SEQUOYAH NUCLEAR PLANT UNIT 1 AND UNIT 2

IMPROVED TECHNICAL SPECIFICATIONS CONVERSION

ITS SECTION 3.2 POWER DISTRIBUTION LIMITS

**Current Technical Specification (CTS) Markup
and Discussion of Changes (DOCs)**

Figure B 3.2.1B-1 (page 1 of 1)
 K(Z) - Normalized $F_Q(Z)$ as a Function of Core Height

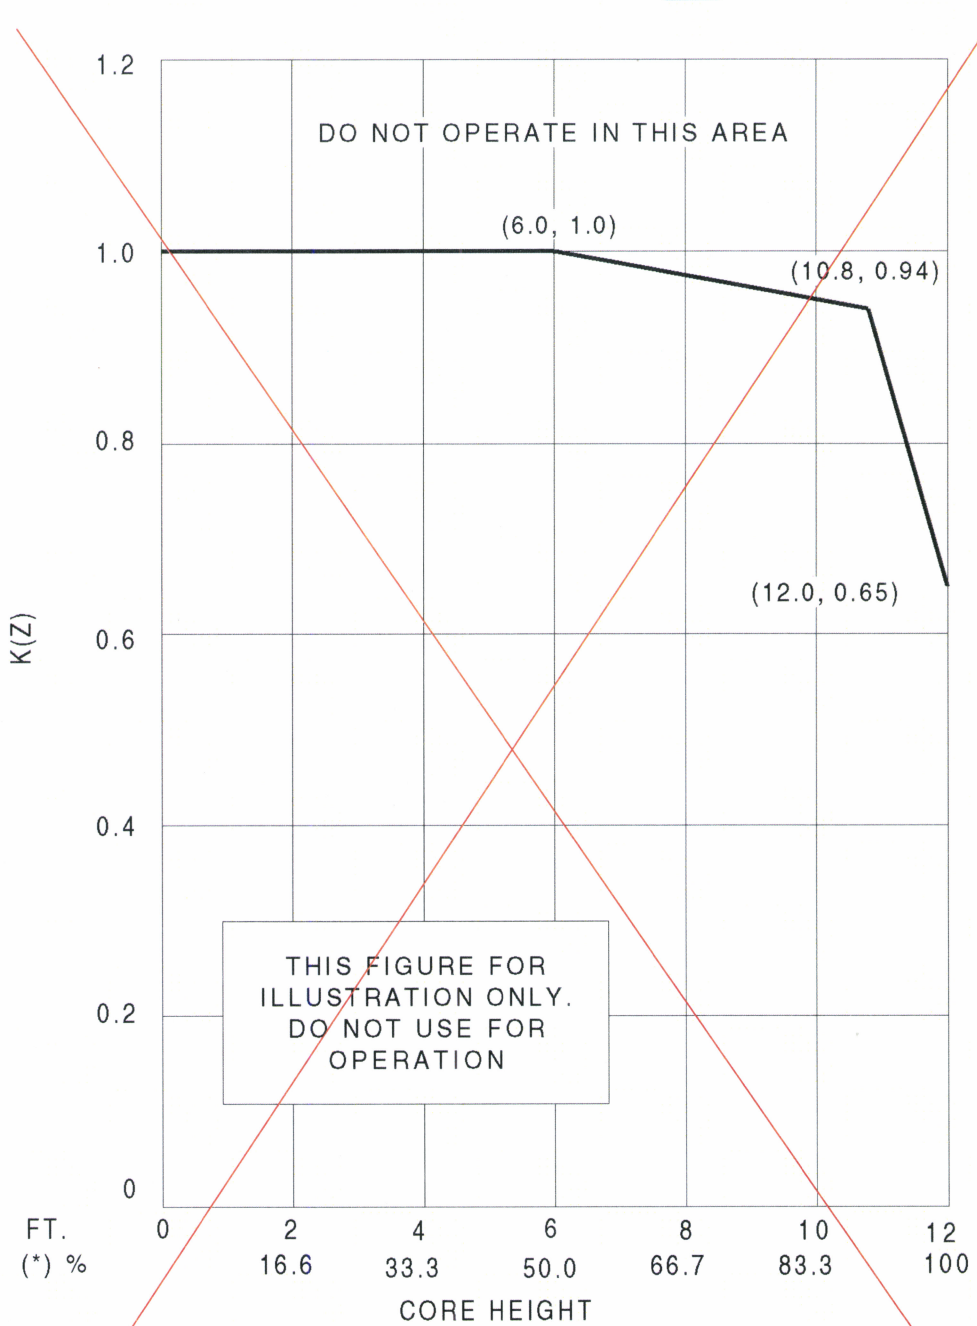
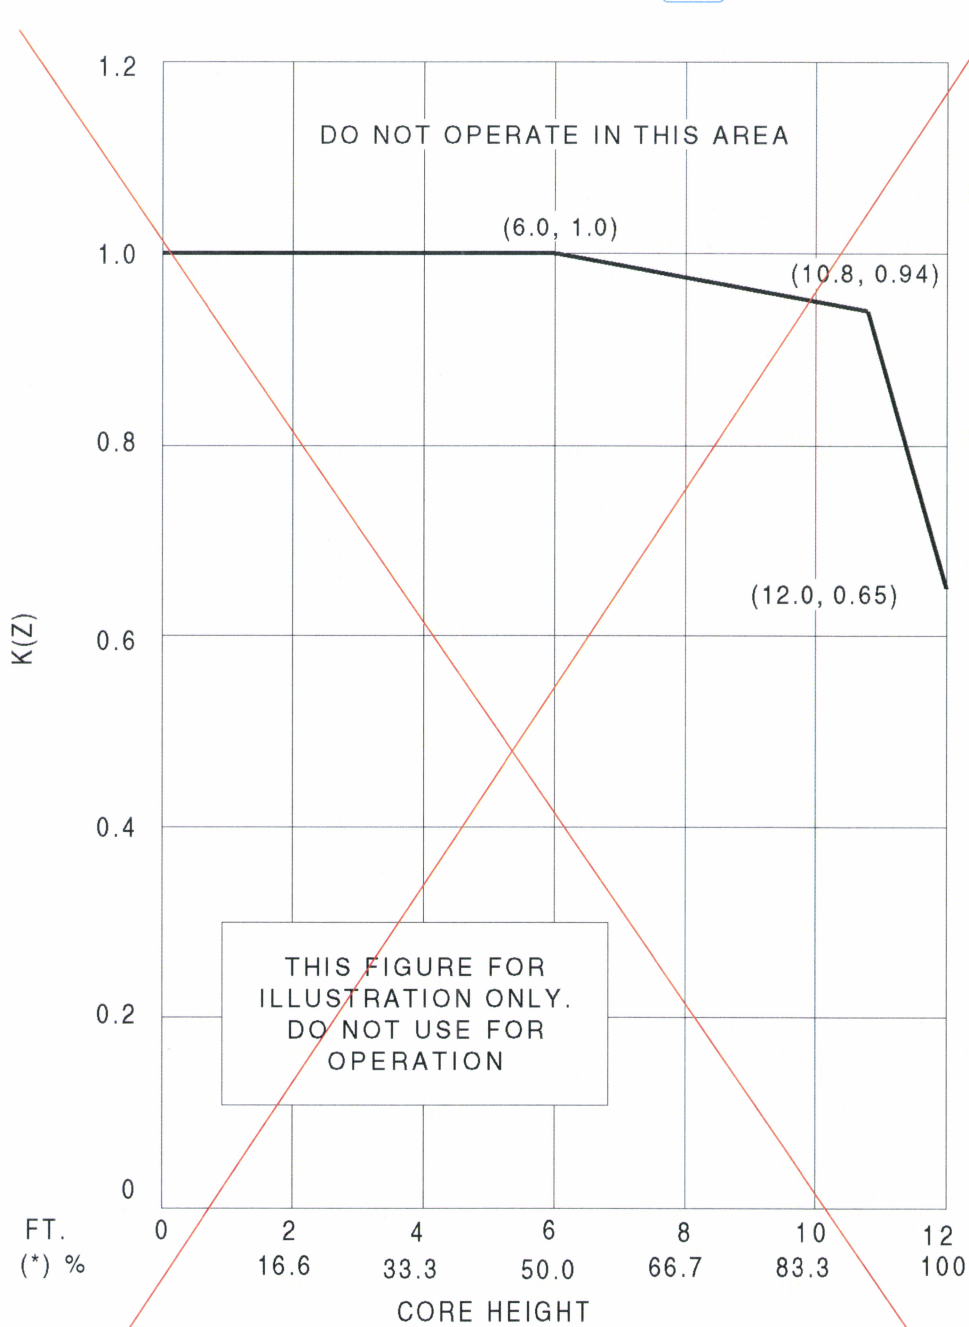
4

2. The RAOC-W(Z) methodology and the Specification designator "B" are deleted because they are unnecessary. (Only one Heat Flux Hot Channel Factor Specification is used in the SQN ITS.) This information is provided in NUREG-1431, Rev. 4 to assist in identifying the appropriate Specification to be used as a model for the plant specific ITS conversion, but serves no purpose in a plant specific implementation. In addition, the CAOC- F_{XY} and CAOC-W(Z) methodology Specification Bases (ISTS B 3.2.1A and B 3.2.1C) are not used and are not shown.

Figure B 3.2.3B-1 (page 1 of 1)
AXIAL FLUX DIFFERENCE Acceptable Operation Limits
as a Function of RATED THERMAL POWER

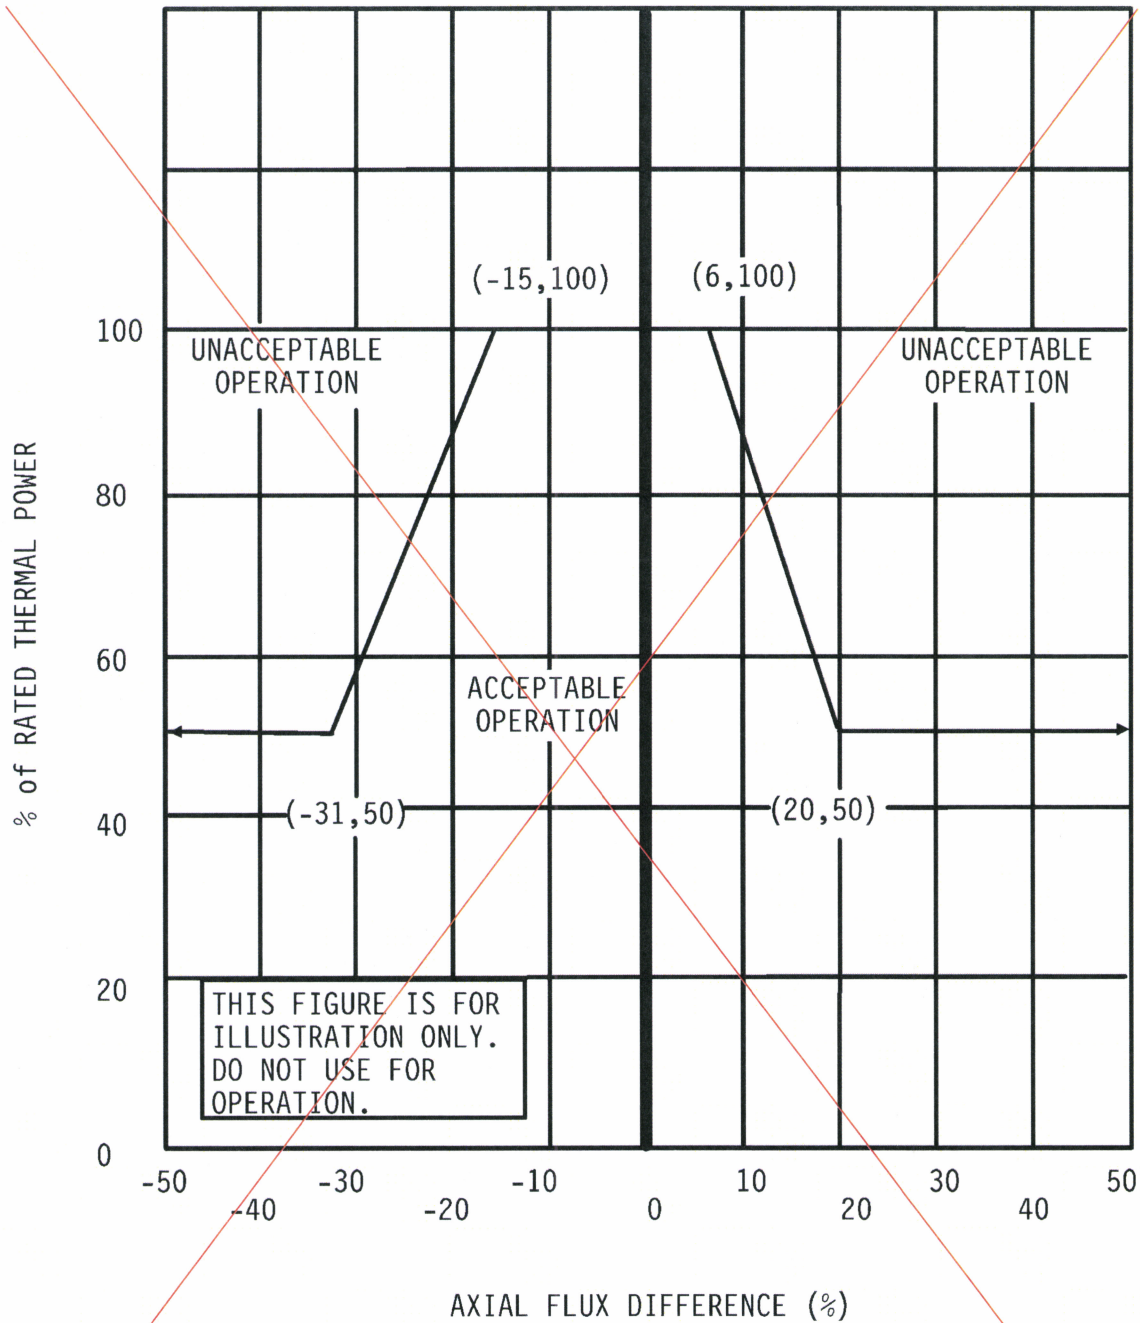
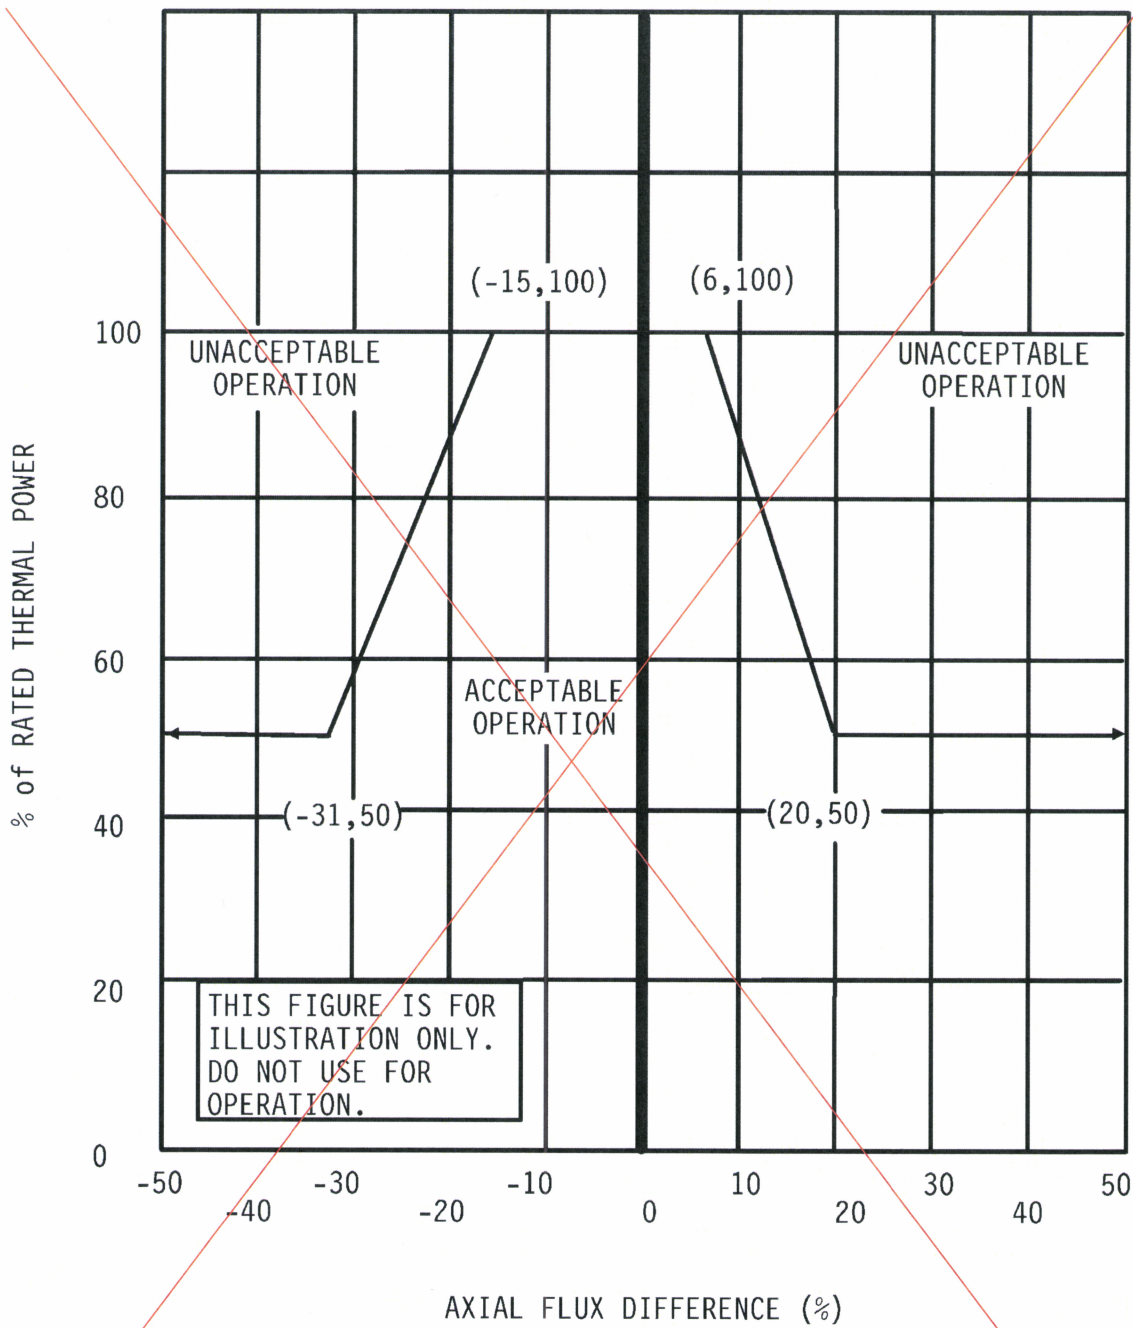
} ①

5. ISTS 3.2.3 Bases contains Figure B 3.2.3B-1. This Figure is located in the Sequoyah Nuclear Plant (SQN) COLR. Therefore, this figure is not included in the Bases for ITS 3.2.3.
